16ZONE1058

Eastern Parkway Law Office

Louisville Metro Planning Commission Public Hearing

January 5, 2017

Applicant's Construction Plan

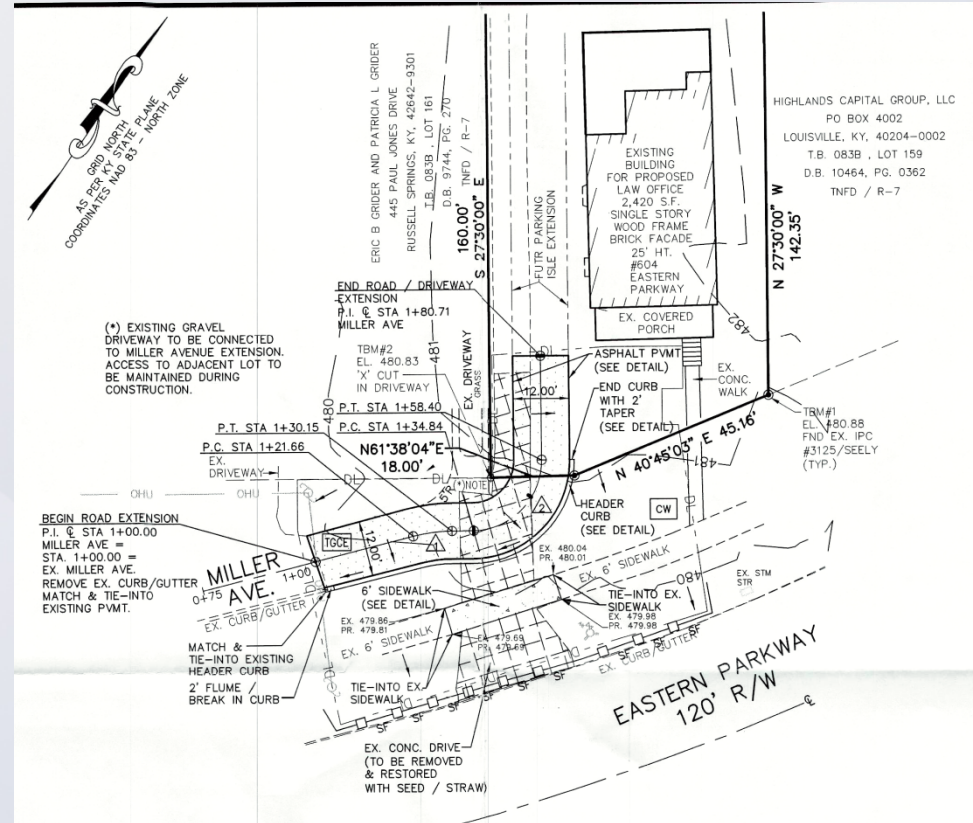
- Unapproved by Transportation Planning but shows intent for handling extension of Miller Ave. within public right-of-way
- Remove driveway apron in ROW and restore with seeds and straw, reconstruct 6' sidewalk
- DDDP should be revised to more accurately reflect intentions as shown on construction plans

Waiver Exhibit

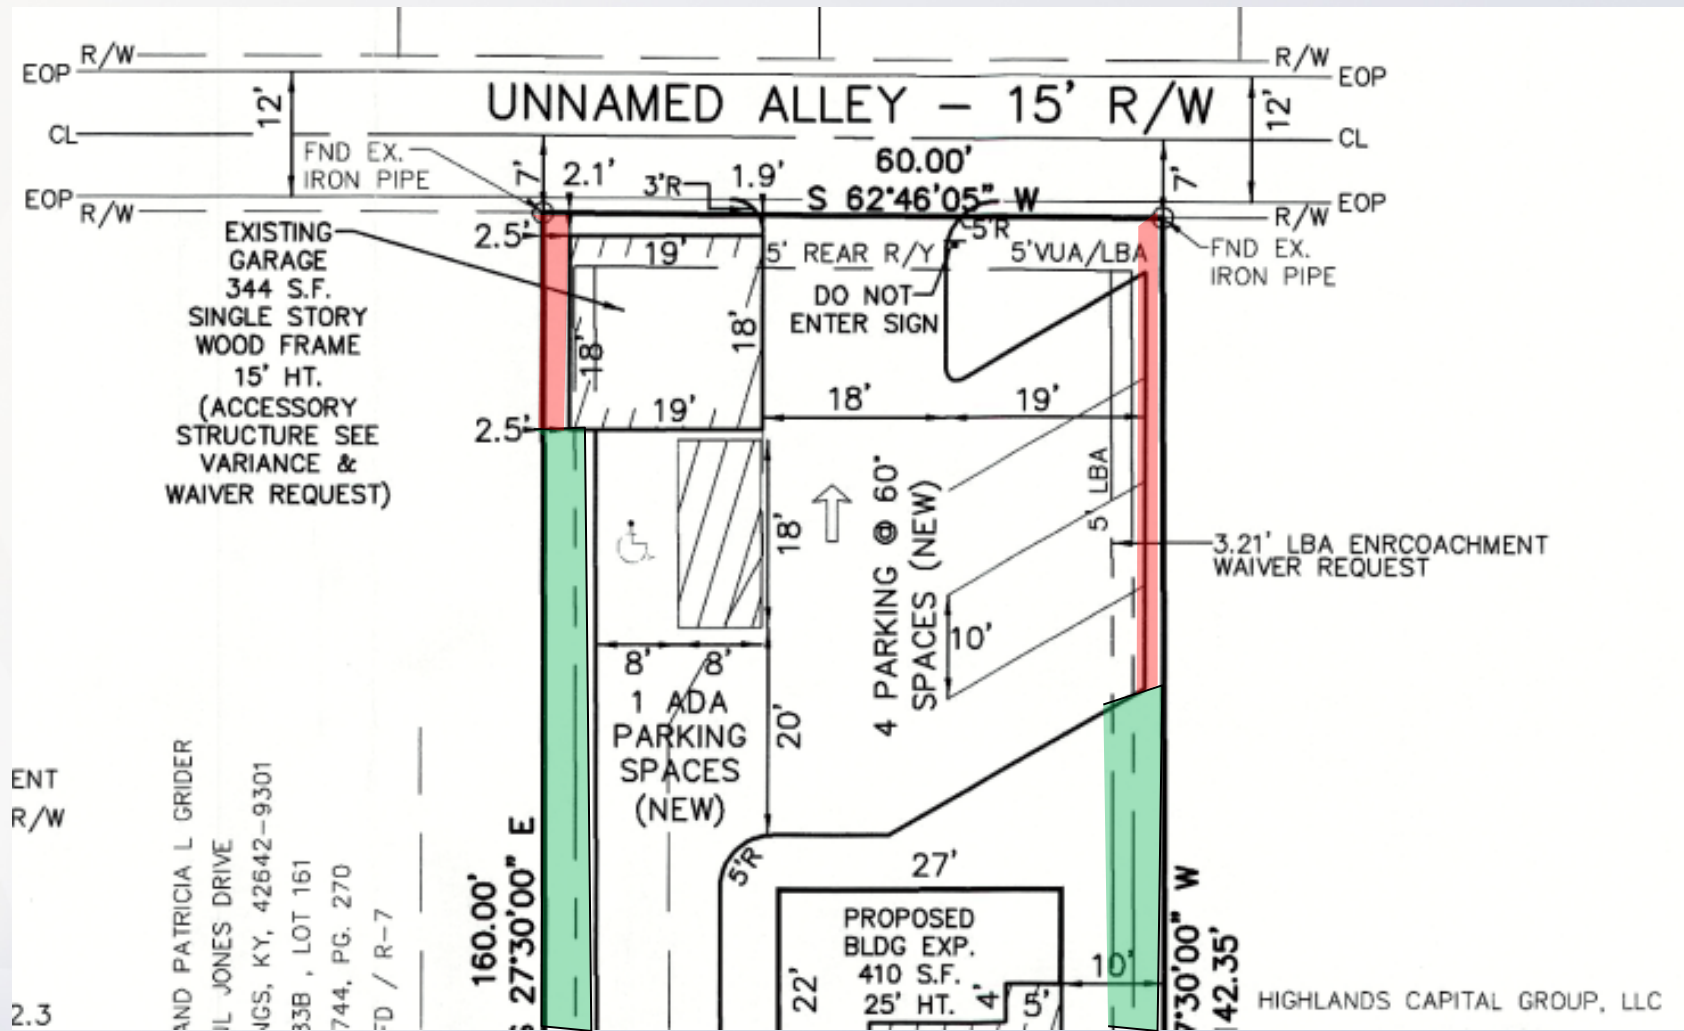
- Change in zoning from R-7 (Multi-Family Residential) to OR (Office/Residential) for .211 acres
- Detailed District Development Plan
 - Waiver from Chapter 10, Part 2, Table 10.2.3 of the LDC to allow the proposed parking lot along the southwest property line to encroach 3.21 feet into the five-foot landscape buffer area and to allow an existing accessory structure along the northeast property line to encroach 2.5 feet into the five-foot landscape buffer area
